**Re: 49 CFR Part 573; Recall of Mercedes-Benz G-Class (463) Turn Signal Grill Covers**

RE: Recall Campaign - Update **Front Turn Signal Grills, Model 463, Model Years 2002 - 2010**

Update to work instructions for dealer inventory and vehicles received from the VPC ONLY.

**Figure 1**

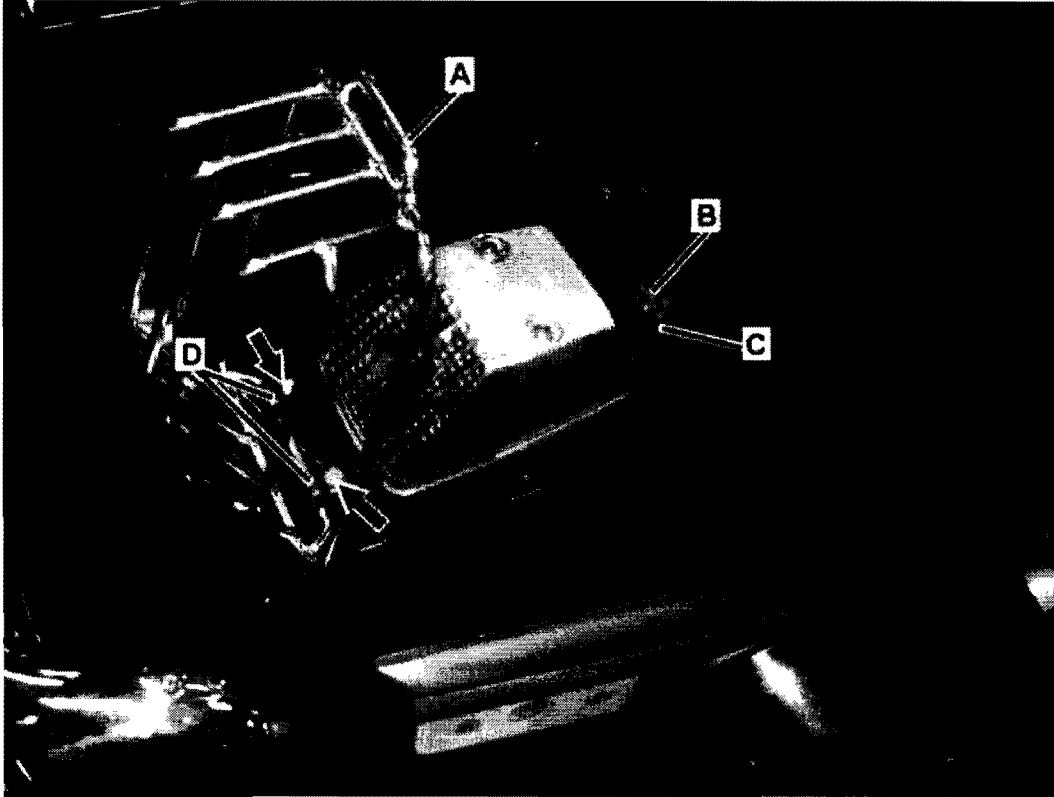
1. Open directional grill (A, Figure 1).
2. Remove torx screw (B, Figure 1) from clip (C) and remove clip.
3. Close direction grill (A, Figure 1) then remove two torx screw (arrows).
4. Remove clips (D, Figure 1) and remove grill (A).

Figure 3

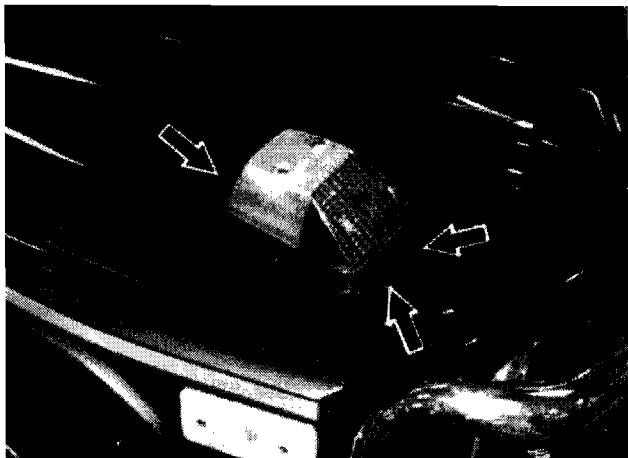
6. Pull body anchor (A, Figure 2) out from fender using locking pliers. Repeat steps 5 and 6 for remaining two body anchors.
7. Install body plugs (arrows, Figure 3) into 3 anchor holes using even pressure.
8. Repeat procedure on opposite side.

Figure 4

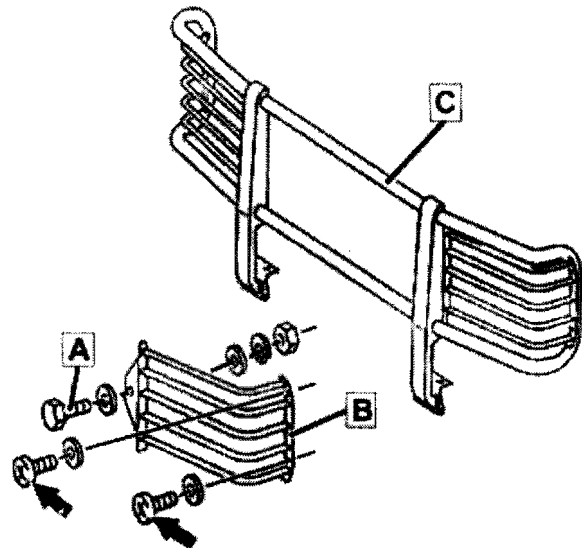
- Remove bolt (A, Figure 4) and two screws (arrows) then remove headlamp grill (B) from front brush guard (C). Repeat this step on opposite side.
